| <b>Model</b>                   | Editor Board for PDC - 1E         | <b>Volt/Hz</b> | <b>Date of Modification</b> | <b>Serial Number</b> |
| <b>Modified Article</b>        | Editor Hinge and Mounting Bracket |                |                             |                      |
| <b>Reason for Modification</b> | Parts catalog correction          |                |                             |                      |

| Model                   |               | Editor board for PDC - 1E (-25, -27 only)                                |               |                      |      |                        |                      | Volt/Hz                                 | Date of Modification | Serial Number |      |

| Model                   |               | Editor board for PDC - 1E (-25, -27 only)                                |               |                      |      |                        |                      | Volt/Hz                                 | Date of Modification | Serial Number |      |
|-------------------------|---------------|--|---------------|----------------------|------|------------------------|----------------------|---|----------------------|---------------|------|
| Modified Article        |               | Intermediate Board   |               |                      |      |                        |                      |   |                      |               |      |

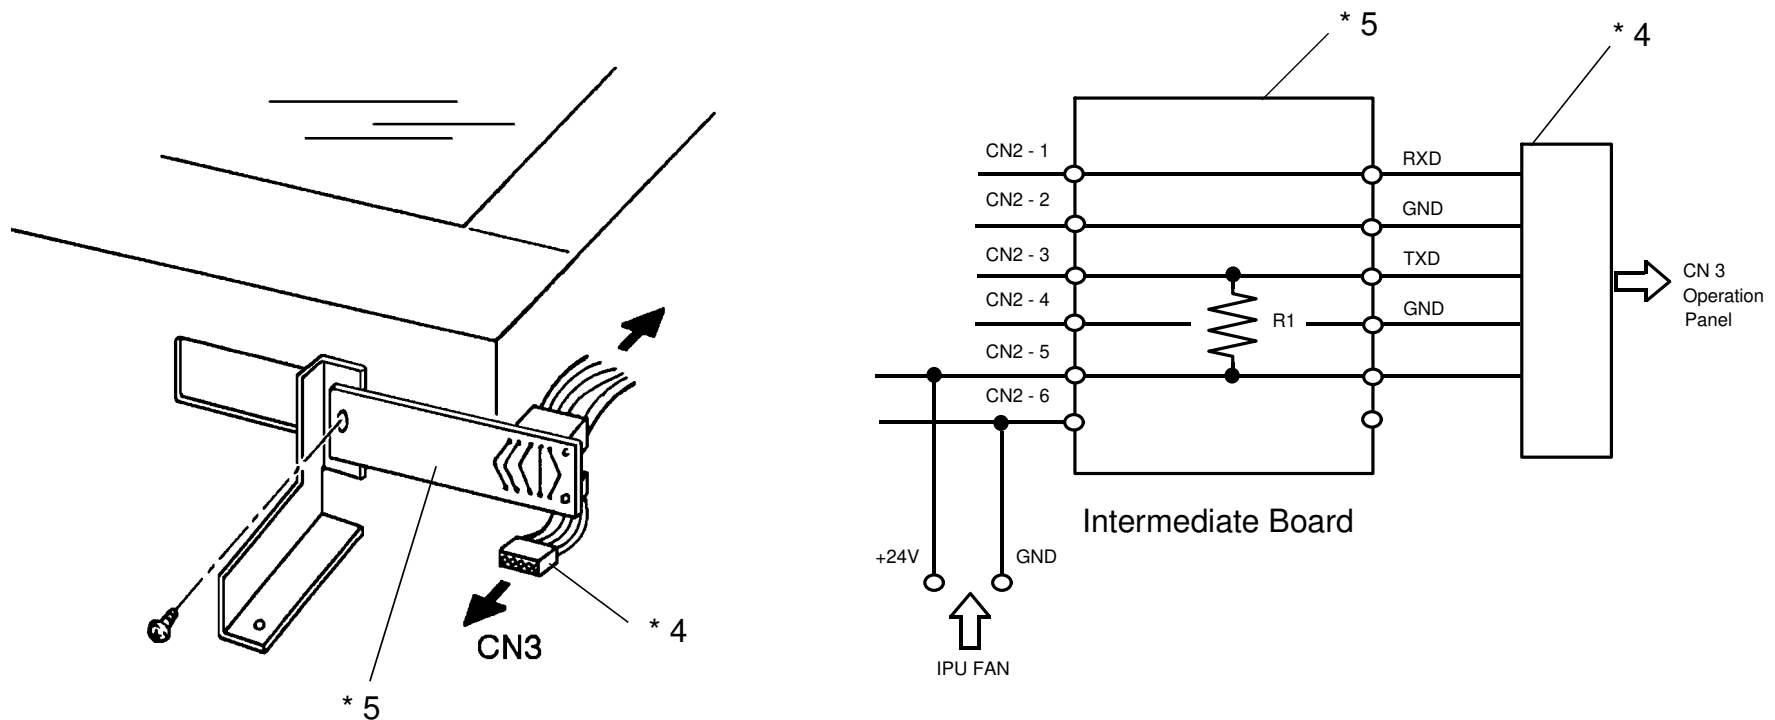
| Model                   |               | Editor board for PDC - 1E (-25, -27 only)                                |               |                      |      |                        |                      | Volt/Hz                                 | Date of Modification | Serial Number |      |
|-------------------------|---------------|--|---------------|----------------------|------|------------------------|----------------------|---|----------------------|---------------|------|
| Reason for Modification |               | To stabilize the 5V line level between the editor board add the PDC - 1E |               |                      |      |                        |                      |   |                      |               |      |

The level of Signal TXD (Editor → Copier) was not enough for being detected by the copier. So, some editor boards did not work at all. To solve this problem, we added an intermediate board [\* 5] and an intermediate harness [\* 4]. This board has 1 K OHM resistor on it and this resistor is connected between pin no.3 (TXD) and pin no. 5 (24V). So, the level of TXD is increased, to a sufficient level.

| Model                   |               | Editor board for PDC - 1E (-25, -27 only)                                |               |                      |      |                        |                      | Volt/Hz                                 | Date of Modification | Serial Number |      |
|-------------------------|---------------|--|---------------|----------------------|------|------------------------|----------------------|---|----------------------|---------------|------|
|                         |               |  | A9885517      | Intermediate Harness |      | 0 → 1                  |                      |   |                      | * 4           | 5    |
|                         |               |  | A9885519      | Intermediate Board   |      | 0 → 1                  |                      |   |                      | * 5           | 5    |
